**Subject:** 45 Lantana Avenue, Wheeler Heights NSW 2097 DA 2020/1743 WRITTEN  
SUBMISSION: LETTER OF OBJECTION Submission: Moss & Walton

**Re:**  
**45 Lantana Avenue, Wheeler Heights NSW 2097**  
**DA 2020/1743**

**WRITTEN SUBMISSION: LETTER OF OBJECTION**  
**Submission: Moss & Walton**

We object to the latest amended plan, Site Plan Drawing A02 rev C, dated 9 July 2021. [attached]

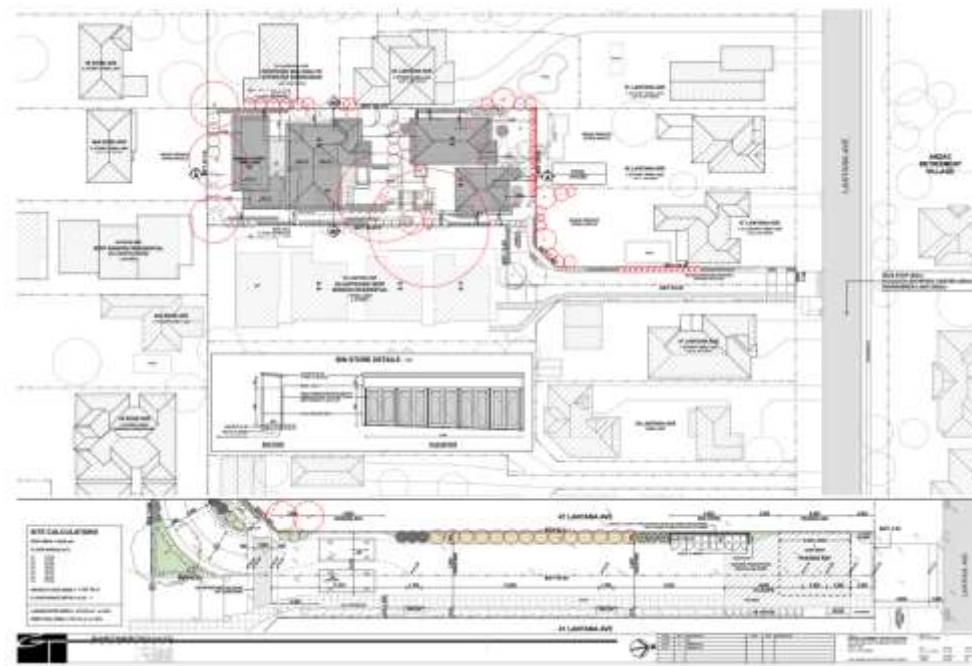
Council will note that the 1:100 drawing, and the 1:250 drawing do not accord.

The 1:100 drawing shows two Passing Bays immediately adjacent the boundary of 47 Lantana Avenue.

The Northern Passing Bay removes the 0.9m deep soil landscape zone, that was providing privacy screening to 47 Lantana Avenue. The Northern Passing Bay also is immediately adjacent letter boxes and bins to be used by HSPD residents. This is totally unacceptable.

The Southern Passing Bay removes the 0.9m deep soil landscape zone, that was providing screening to 47 Lantana Avenue. The Southern Passing Bay now has no landscape privacy screening to the private open space facing 47 Lantana Avenue. This is totally unacceptable.

The Garage Bin Store is now set 1m away from the opening bedroom windows of 47 Lantana Avenue. The smell and noise from such a large garbage area set immediately adjacent opening neighbours windows is totally unacceptable. The bin store needs to be relocated to within the basement.

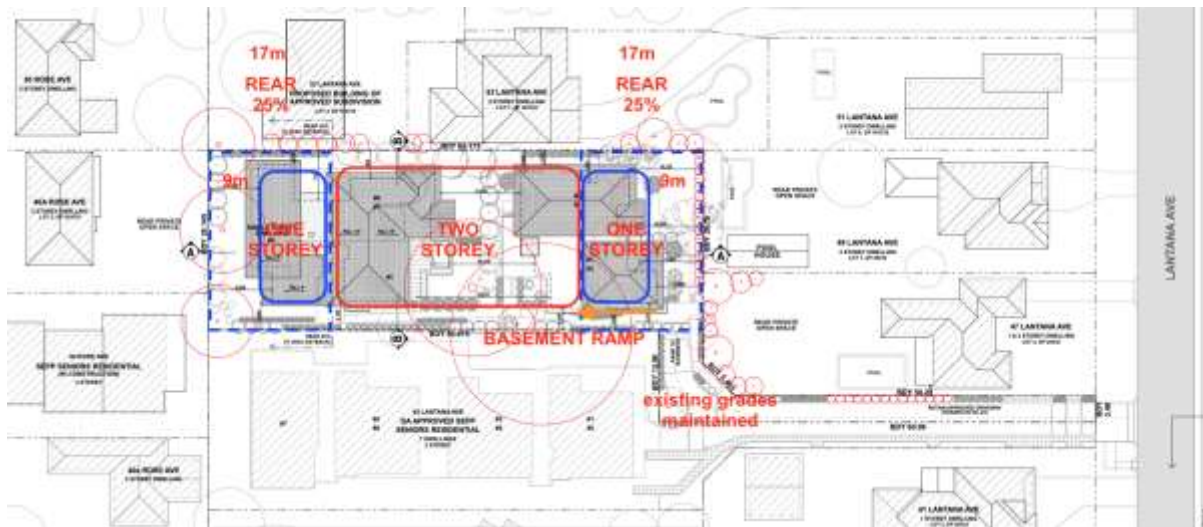
To overcome the 2m high entry zones built upon the boundary to 47 Lantana Avenue, and to avoid the 2m terraces that are positioned above the fence level to both 47 Lantana Avenue and 49 Lantana Avenue, we suggest the only alternative is to maintain the existing grades on the site, and for the main basement ramp and entry sequence to begin with a 9m setback to the subject site's northern boundary.

We contend that the Clause 40 [4] [c] 'Rear 25%' restriction [14m] be enacted to the subject site's northern boundary, with the provision of a single storey envelope setback 9m to the subject site northern boundary. These single storey units facing to the subject site's northern boundary must match the ground level existing at RL 62.4 to avoid overlooking to our properties.

The two-storey component can then be positioned centrally to the subject site, with allowances for the TPZ of both major retained trees.

Any redesign would require the garbage storage area to be relocated to the basement. The current solution positions a very large storage zone immediately adjacent opening windows to neighbour's bedroom and highly used rooms. This is both unreasonable and unacceptable.
